# Access Compliance Report

## Public Rights-of-Way

Intersection ID: 30009	Main Street: BACKWATER_DR	Cross Street: OLD_CAROLINA_DR	Location: SE
ADA ID: D066887F0EF2	Ramp Type: PerpDiag	Initial Pass/Fail: Fail	Overall Compliance: No
Codes/Mitigation Info/Possible Solution			Severity Score: 25
			Field Measurements/Component Compliance

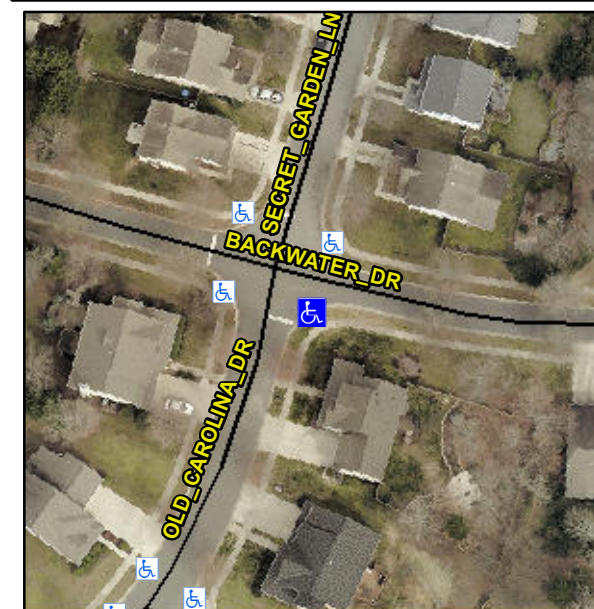
**Not Found, R304.2.2, R304.5.3**

Compliance	Description	Data	Compliance	Description	Data
N/A	Ramp Length (in)	32.0	No	Ramp Slope (%)	10.3
Yes	Ramp Width (in)	48.0	No	Ramp XSlope (%)	5.1
N/A	Flare Type LT	N/A	N/A	Flare Type RT	N/A
N/A	Flare Slope LT (%)	N/A	N/A	Flare Slope RT (%)	N/A
N/A	Flare Traversable LT?	N/A	N/A	Flare Traversable RT?	N/A
N/A	Landing Length (in)	N/A	N/A	DWS Provided?	N/A
N/A	Landing Width (in)	N/A	N/A	DWS Contrast?	N/A
N/A	Landing Slope (%)	N/A	N/A	DWS Length (in)	N/A
N/A	Landing X Slope (%)	N/A	N/A	DWS Full Width?	N/A
N/A	Landing Curb? (Y/N)	N/A	N/A	DWS Offset (in)	N/A
N/A	Shared Landing?	N/A			
N/A	Gutter Ponding?	N/A	N/A	Gutter Slope (%)	N/A
N/A	Gutter Lip Ht (in)	N/A	N/A	Gutter X Slope (%)	N/A
N/A	Painted X Walk1?	No	N/A	Painted X Walk2?	No
	X Walk 1 Direction	To N		X Walk 2 Direction	To W
N/A	X Walk 1 Width (in)	N/A	N/A	X Walk 2 Width (in)	N/A
	X Walk 1 Slope (%)	1.8		X Walk 2 Slope (%)	0.5
	X Walk 1 X Slope (%)	2.2		X Walk 2 X Slope (%)	4.6

N/A	Ramp inside XWalk1?	N/A	N/A	Ramp inside XWalk2?	N/A
	Road Slope (%)	3.7	N/A	Clear Space?	N/A
	Road X Slope (%)	4.2	N/A	Clear Space to XWalk (in)	N/A
N/A	Any Obstructions?	N/A	N/A	Storm Grate/Utility Hazard?	N/A
	Obstruction Type			Storm Grate/Utility Type	
		N/A			N/A
			Yes	Surface Condition? (G/P)	Good

**Remove & Replace Curb Ramp With Two New Directional Ramps or Equivalent.**
